Questions/Answers

Solicitation 36C26323R00001

Upgrade Mental Health Lock Ward

Date: October 25, 2022	Project: VA FM Upgrade Mental Health Lock Ward
To: Stone Group Architects	Project #: VAMC 68-20-102 WPE: BR21045
From: West Plains Engineering 1750 Rand Road Rapid City, SD 57702	Project Location: Ft. Meade, SD Addendum #: Addendum 0001

Project title	CONSOLIDATE MHBS
Date	11/29/99
Project No.	568-305
Building Number	148
Checked	MJH
Drawn	ZPB
Location	FORT MEADE, SD
DRAWING NO.	148-8
Dwg. of

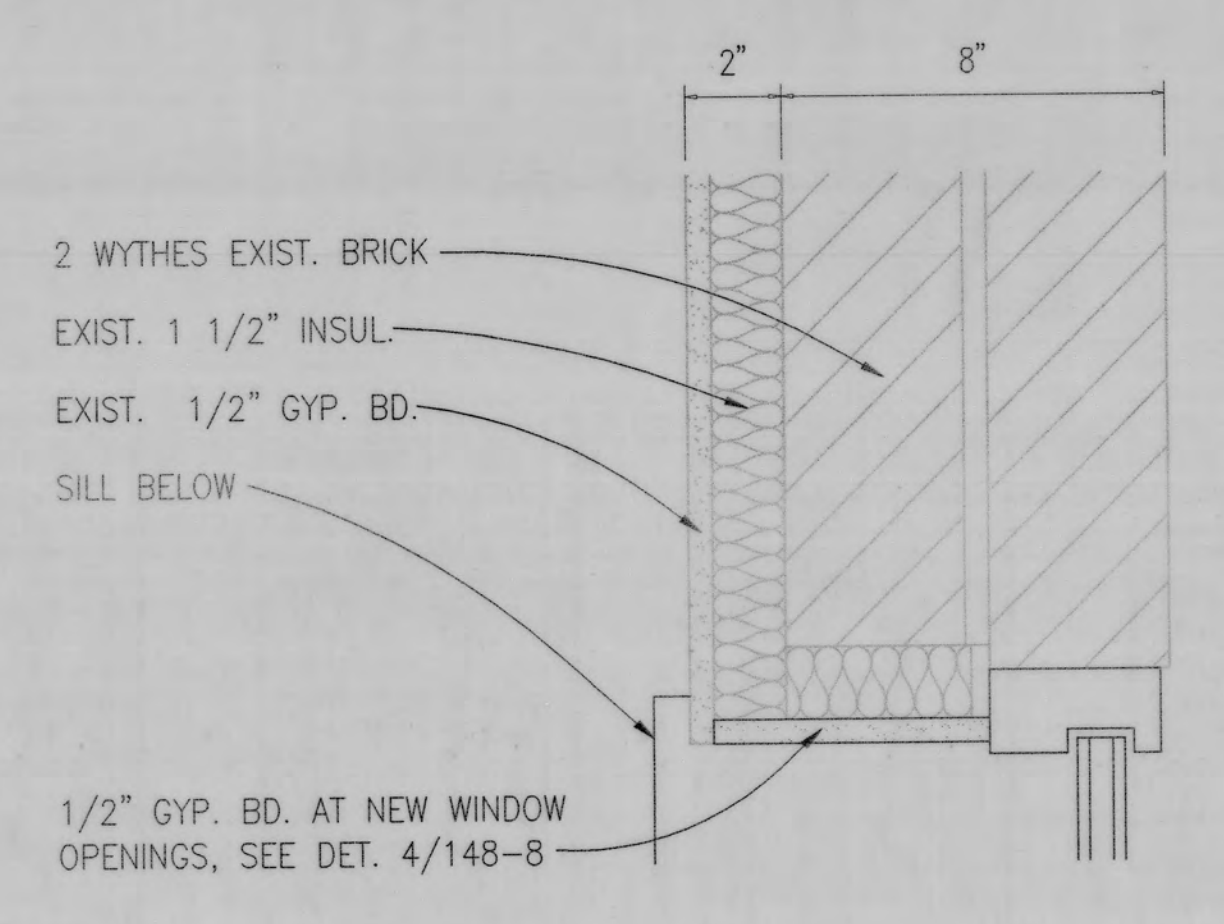
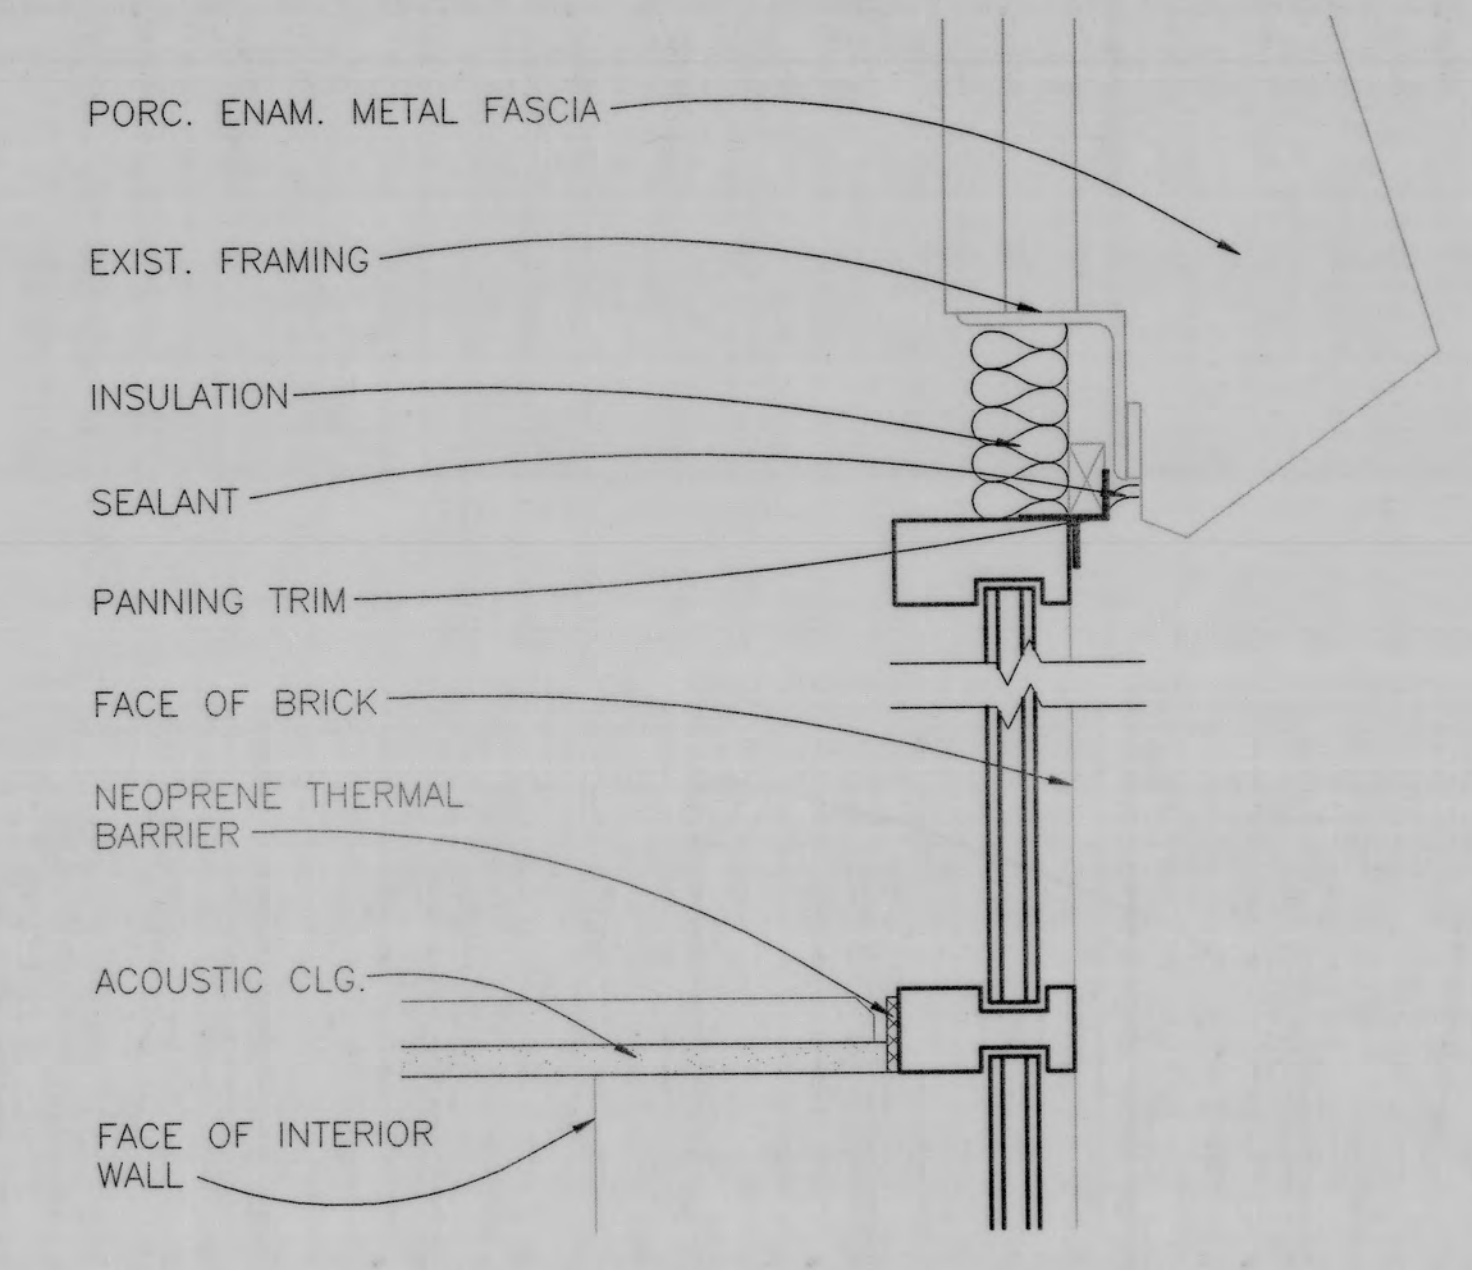
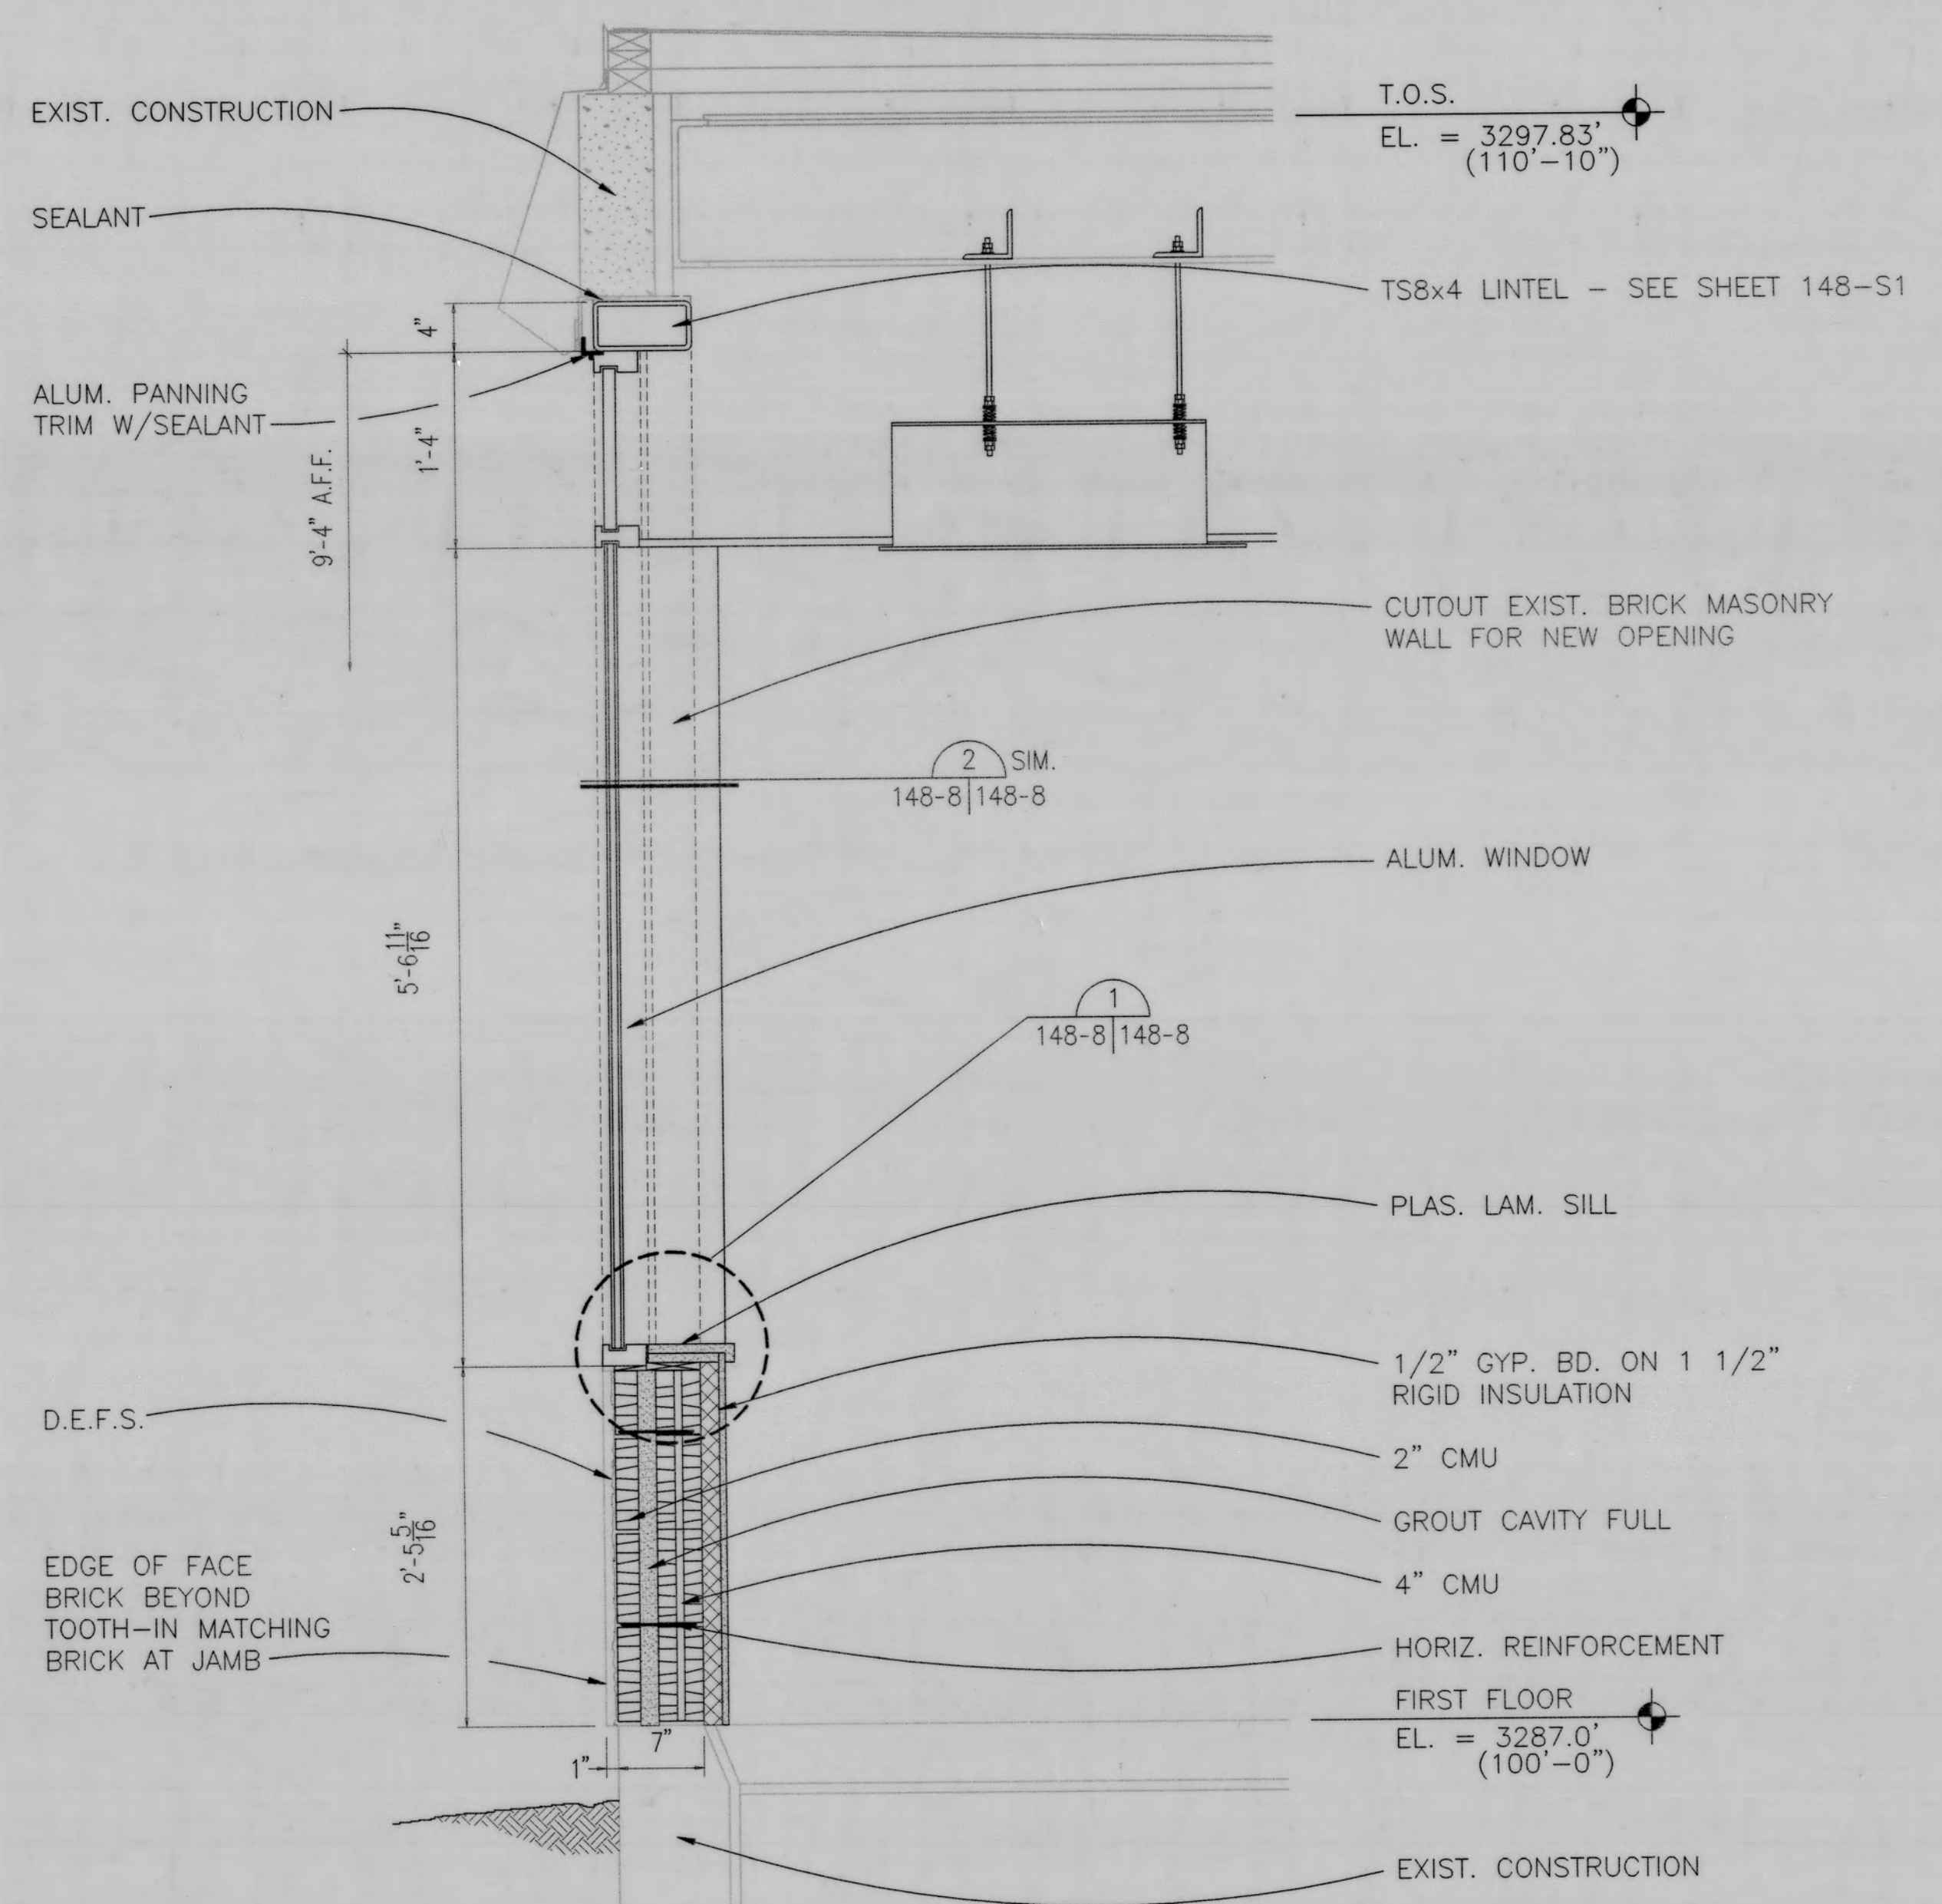
7	DIV 12 Please confirm the specs 12 36 00 are referring to window sills and not countertops. Please confirm what window types are to receive window sills. Please confirm Material, Colors, and edging.	AE: Yes, Division 12 is included for solid surface window sills. Windows getting sills are noted by keynote 6.60C on Sheet AE-101.
8	Period of Performance Does the PoP account for long lead times certain Divisions have when procuring material/equipment?	No - we have run into this issue on several of our contracts. If you feel that there are several long lead items, we can provide a limited NTP at the Pre-Construction meeting. When the submittals are approved and the items are expected, we can issue the Notice to proceed.
9	DIV 8 Please confirm that the only new storefront windows will be the (3) type C2 windows.	AE: yes the only fully new aluminum windows are the ones noted C2.
10	DIV 8 Per glass manufacturer the type D, D2, and D6 door lites are too small to be tempered laminated glass. They can be annealed lami but not tempered lami. Please advise	AE: we confirmed with a manufacturer that the size of the glass is not available as tempered laminated. Please provided annealed laminated glass for these lite only.
